UNITED STATES PATENT AND TRADEMARK OFFICE

Office Action Summary	Application No. 10/664,087	Applicant(s) MALLORY ET AL.	
	Examiner James T. Nelson	Art Unit 3637

DETAILED ACTION

Grande, Fig. 2

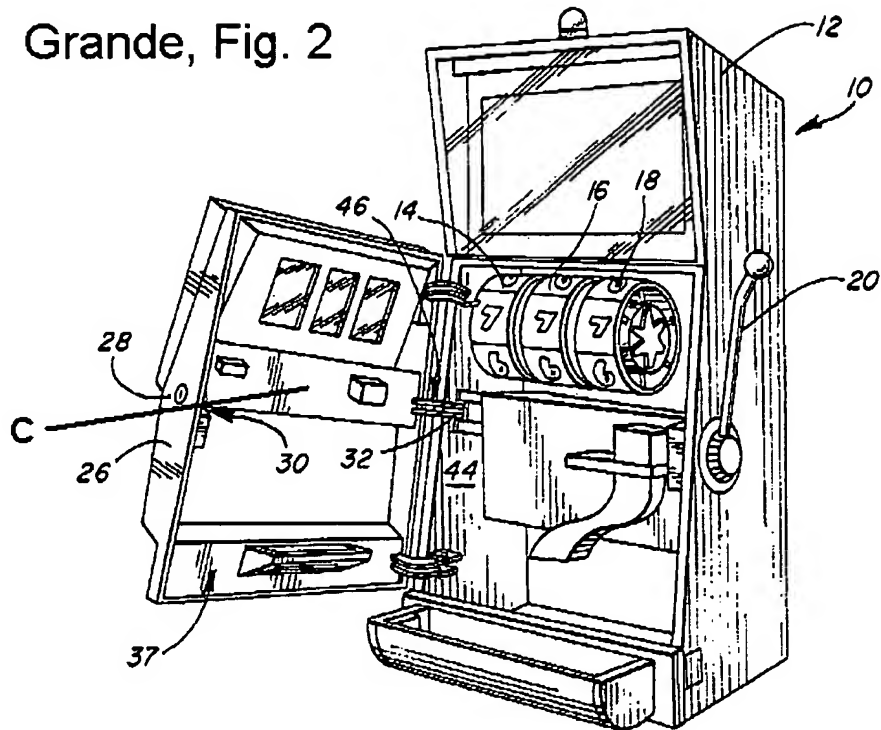
18. Regarding claim 1: In Fig. 2, Grande shows a security enclosure (10) for a gaming machine comprising a main housing (12) defining a chamber (44) and having a major opening, a door assembly (26) operably connected to the main housing (12) and movable between an open position providing external access to the chamber (44) and a closed position securing the major opening, but lacks a door comprising a plurality of components, at least some of the components being elongated members having fasteners at opposed end portions to hold the components together. In Figs. 1 and 5, Ramachandran teaches a front fascia (22) for a security enclosure (10) comprising a plurality of components (136, 144, 146, 152, 156), at least some of the components being elongated members (144, 146, 152, 156), having fasteners (118, 162) at opposed end portions to hold the components together. It would have been obvious to one having ordinary skill in the art at the time of invention to modify Grande's gaming machine door to utilize a plurality of components, as taught by Ramachandran, in order to facilitate the removal and replacement of individual components in the event that a component was damaged instead of replacing the entire door.

19. Regarding claim 2: In Fig. 2, Grande, as modified by Ramachandran, shows the security enclosure of claim 1 including at least one cross member (C) extending horizontally between the left and right side of the door assembly (26). In Fig. 5, Ramachandran also teaches a pair of opposed vertical stiles (144, 146) each having an upper end, an opposed lower end, and an intermediate portion, and including a component (156) extending between the stiles (144, 146) and (156) having opposed ends each having a fastener (162) to engage a corresponding fastener (118) on each of the stiles to hold the components together. Accordingly, it would have been obvious to one having ordinary skill in the art at the time of invention to utilize the components and fasteners of Ramachandran in order to allow the removal and replacement of individual

20. Regarding claim 10: In Fig. 2, Grande, as modified by Ramachandran, shows the enclosure of claim 1. It is readily apparent to the examiner that at least one of the door components having a different surface finish than the other door components is a matter of end user preference, and is therefor afforded no patentable weight.

21. Regarding claim 11: In Fig. 2, Grande, as modified by Ramachandran, clearly shows the enclosure of claim 1 wherein the components are secured closely to each other, such that the door assembly is free of gaps to prevent unwarranted entry to the chamber when the door assembly is closed, as commonly expected of a security enclosure.

Halic, Fig. 3

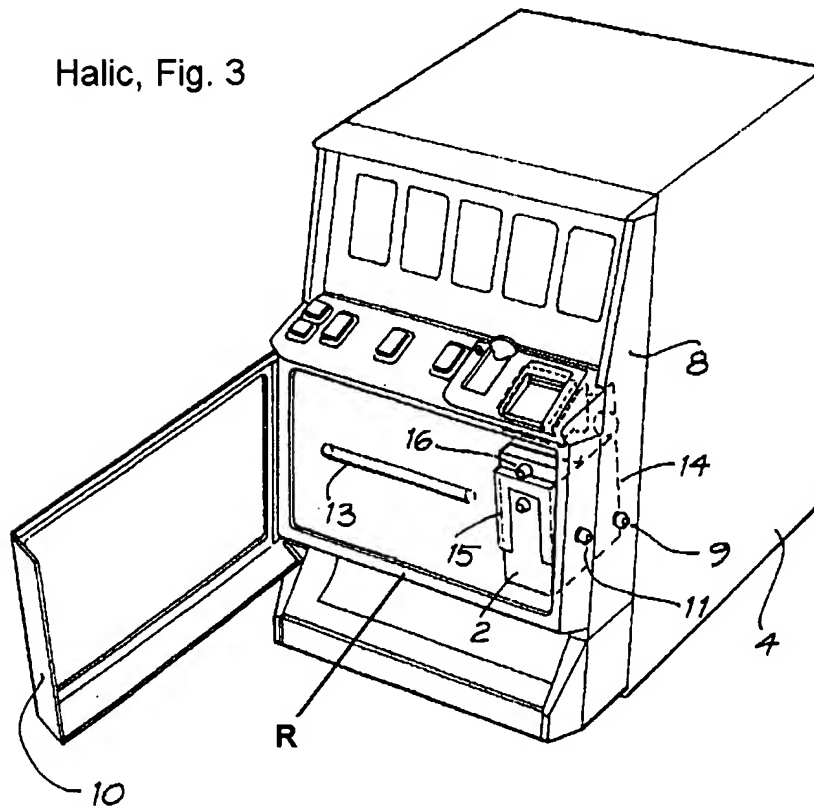
24. Regarding claim 4: In Fig. 2, Grande, as modified by Ramachandran, shows the enclosure of claim 3, but lacks an intermediate rail and a belly door connected to the door and operable between an open position in which a selected one of the rails is visible, and a closed position in which the selected one of the rails is concealed. In Figs. 2 and 3, Halic teaches an intermediate rail (R), and a belly door (10) connected to a door (8) and operable between an open position in which a selected one of the rails (R) is visible, and a closed position in which a selected one of the rails (R) is concealed. It would have been obvious to one having ordinary skill in the art at the time of invention to modify the enclosure of Grande, already modified by Ramachandran, with the belly door of Halic to provide securable access to a portion of the chamber via a lockable secondary door.
